THERMOSTAT LOCATION SUBMITTAL FOR
NANUET BOND PHASE3 HIGH SCHOOL

Job Name: Nanuet Bond Phase 3 High School
JOB #: 44OP-366733
Siemens Industry Inc – Smart Infrastructure
Thermostat location Submittal

Submittal Notes
12/7/2023

RM M111

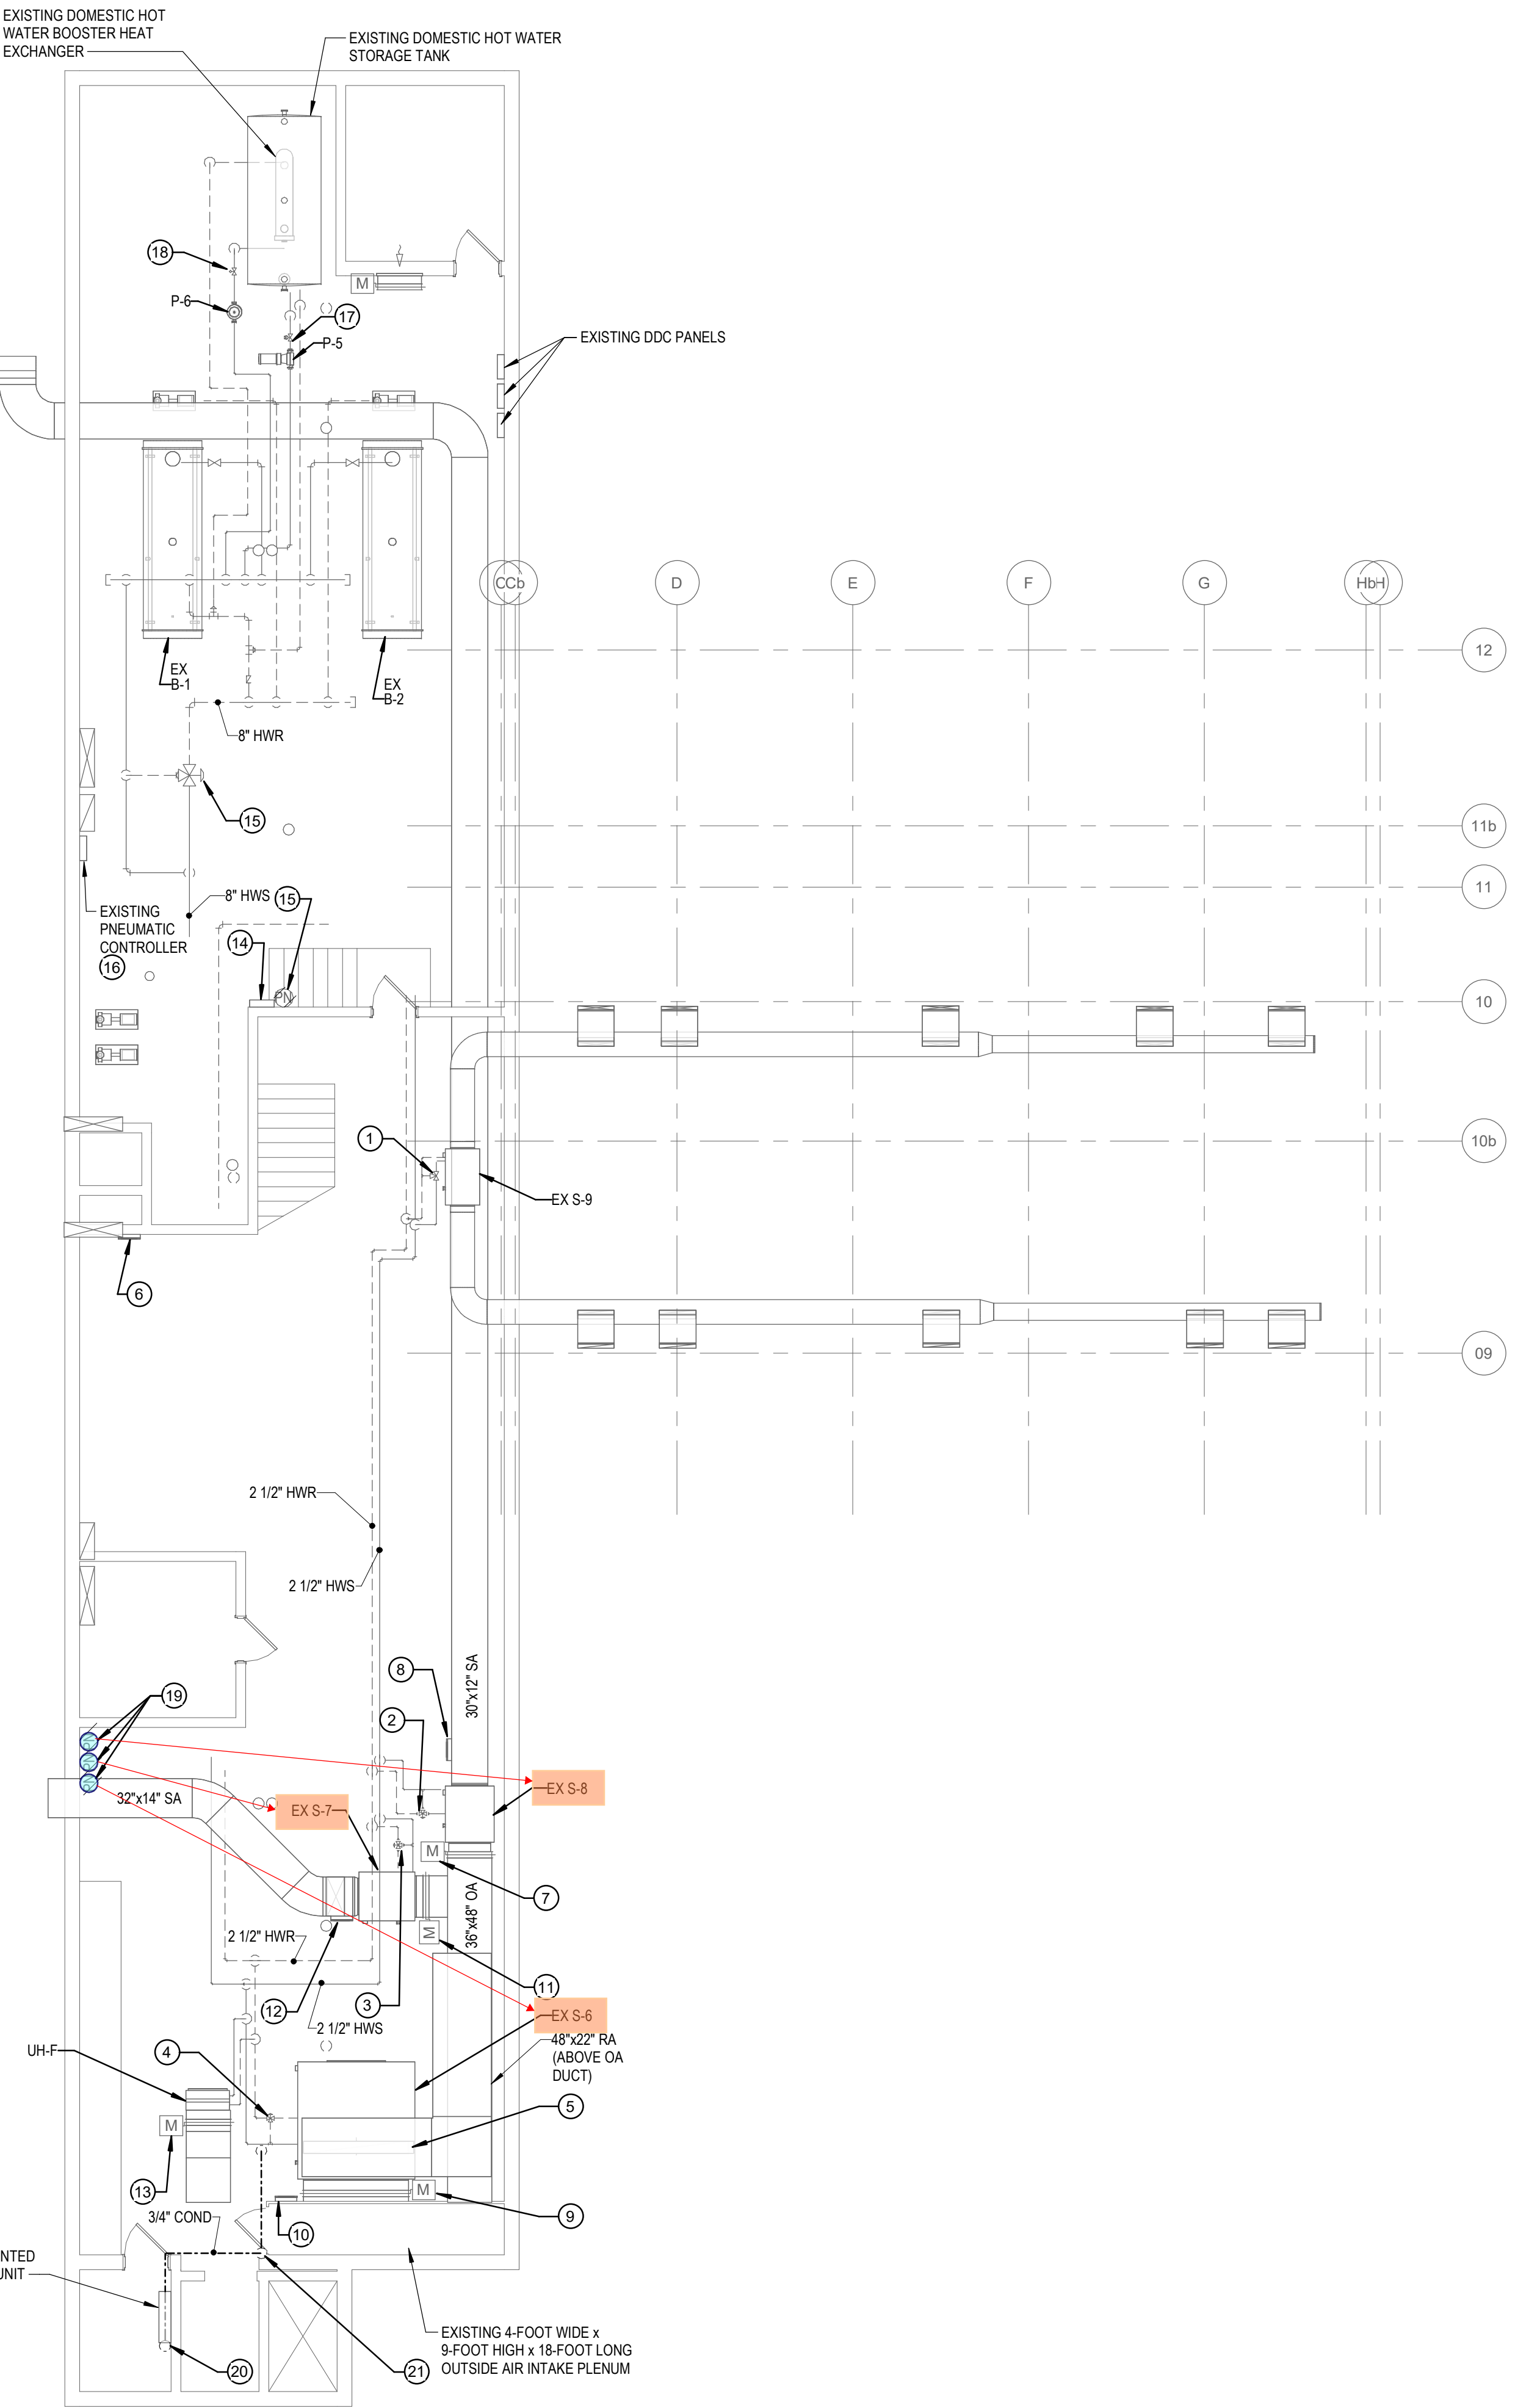
3. At the time of submission, as per DWG BM-M111, UV-MS-3 and FT-MS-1 serving classroom 102A are sharing a single thermostat. Siemens proposes a new BACnet thermostat which will be controlling the FTR valve. Space temperature reading from this thermostat will be shared with UV-MS-3. New separate thermostat is not considered for UV units.

BM-M112

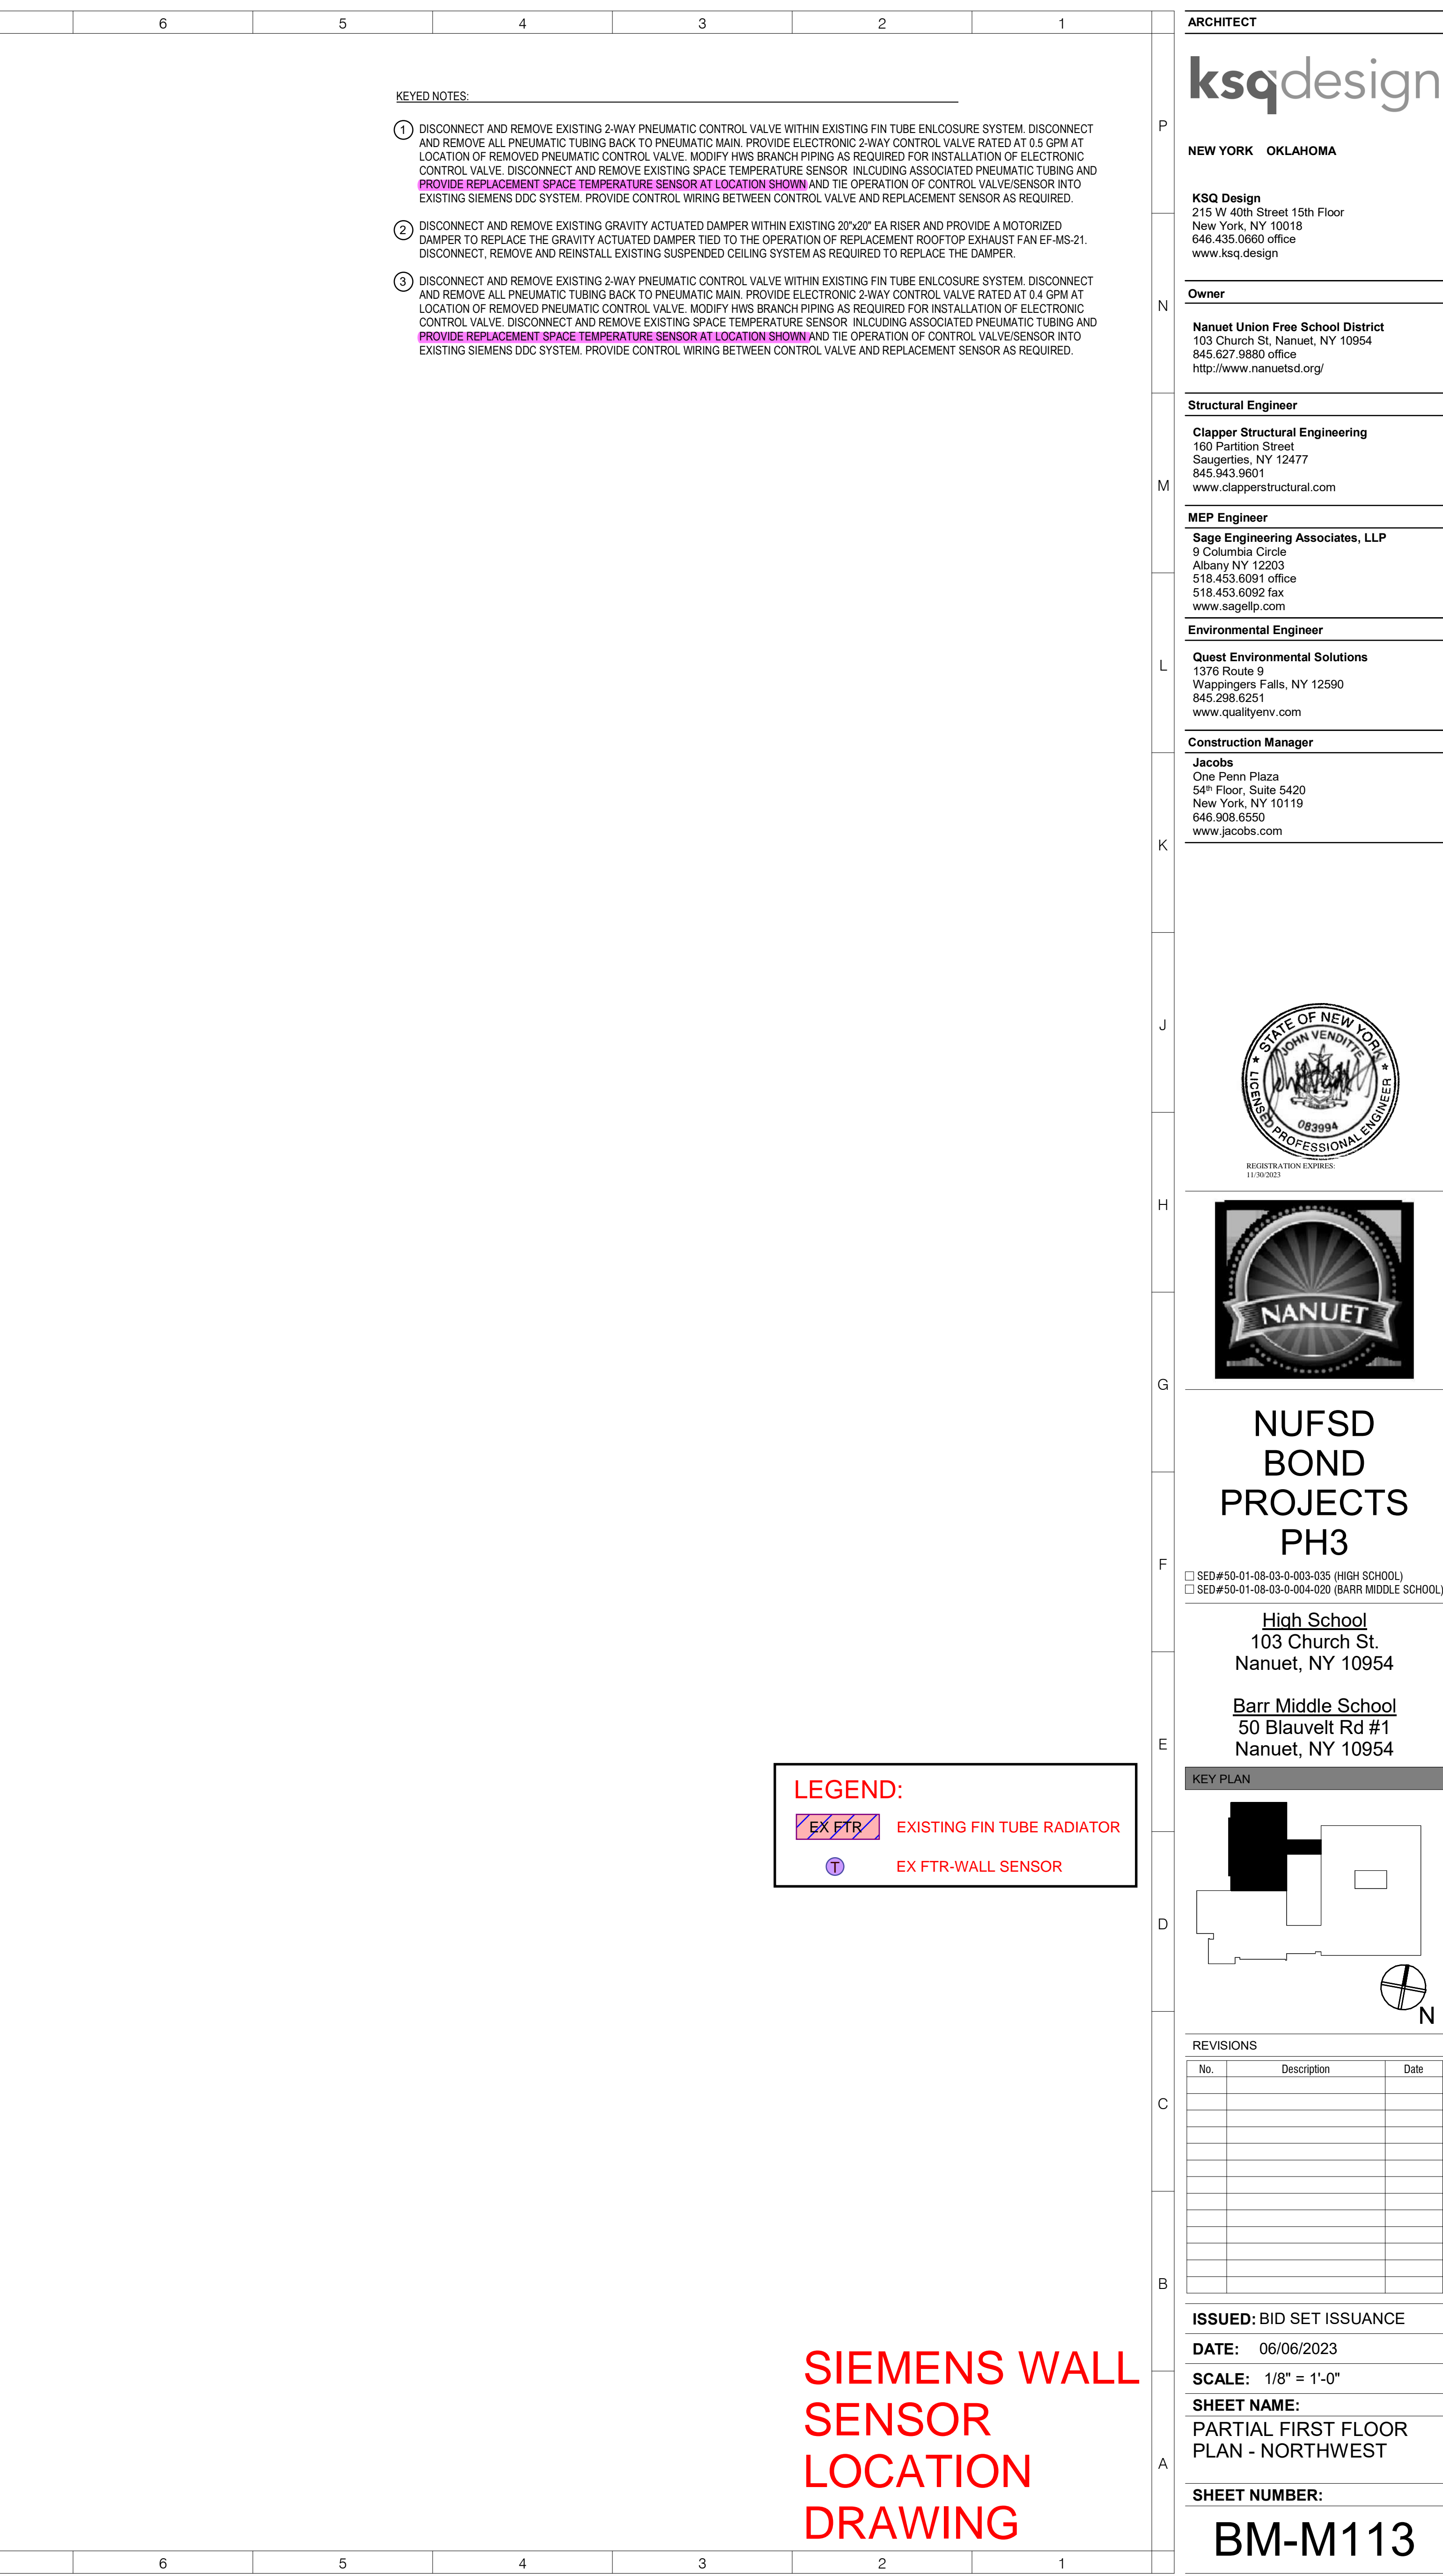
1. BACnet thermostats are proposed for controlling the existing & new FTR's, Heating Radiation & Convector Units.
2. At the time of submission, as per DWG BM-M112, note-4 thermostat is connected to EX S-2. However, as per note-28 the same thermostat is mentioned as it will be controlling the 2-way valve for EX FTR. Thereby new BACnet thermostat will be provided for EX FTR and temperature reading will be shared with EX S-2.
